MEMORANDUM

Subject: Mall of America Transit Station Renovations Project
Existing Ponding Elevation

Exhibit 2 - 100-Year Hydraulic Grade Line at 11.75 Hours

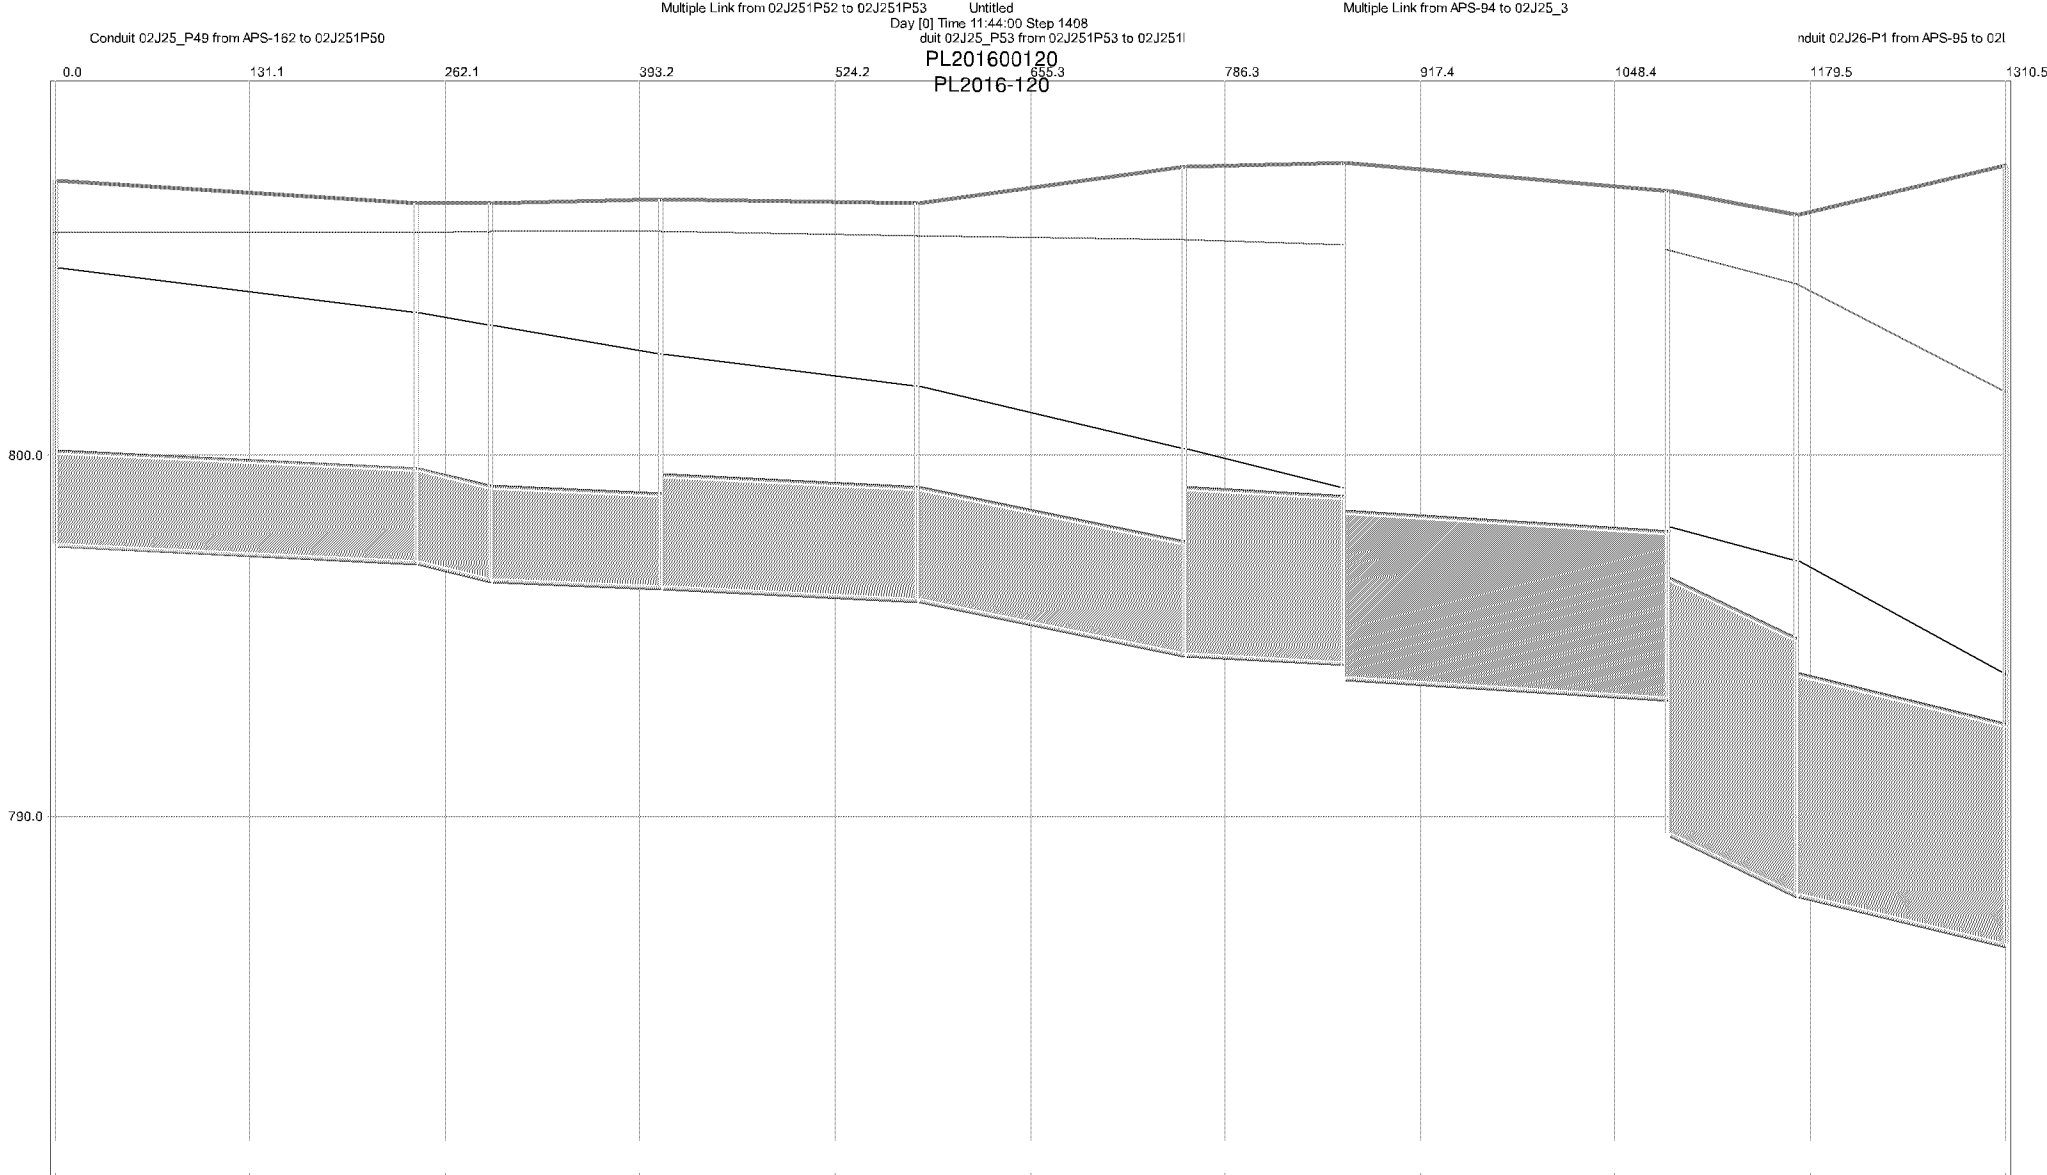
The attached *Exhibits 2 and 3* show the 100-year hydraulic grade line of the storm sewer downstream of the Transit Station at two points in time during a hypothetical 24-hour storm event. *Exhibit 2* is the profile at approximately 11.75 hours into the event. This profile shows a steep hydraulic grade line through the storm sewer immediately adjacent to the Transit Station and a low tailwater in the downstream trunk line. This indicates local ponding may occur due to an undersized lateral near the Transit Station.

Exhibit 3 - 100-Year Hydraulic Grade Line at 12.15 Hours

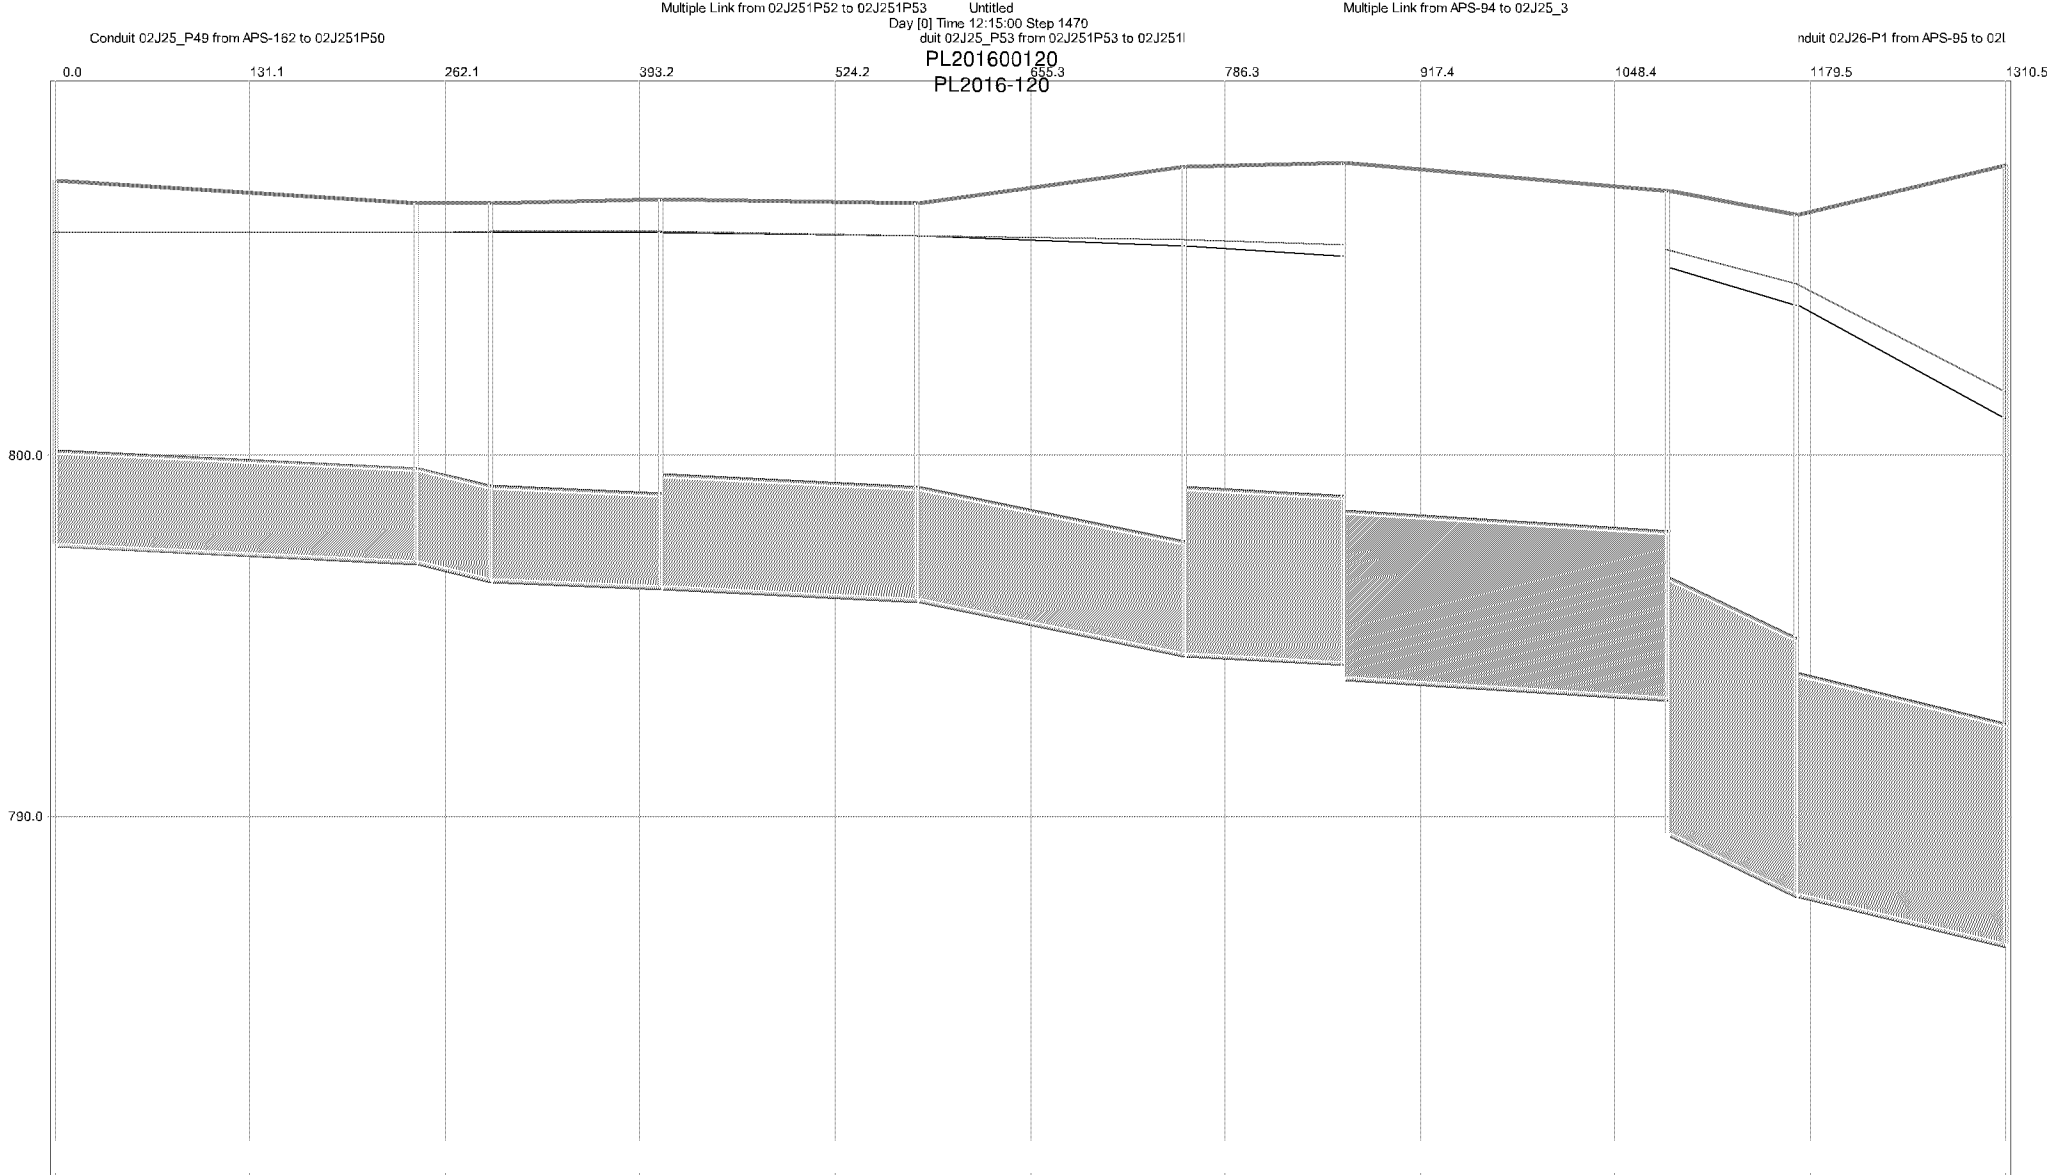
Exhibit 3 is the profile approximately 12.25 hours into the event. This profile shows a flat hydraulic grade line in storm sewer immediately adjacent to the Transit Station and a high tailwater in the downstream trunk line. This indicates local ponding also occurs due to an undersized trunk line downstream of the Transit Station.
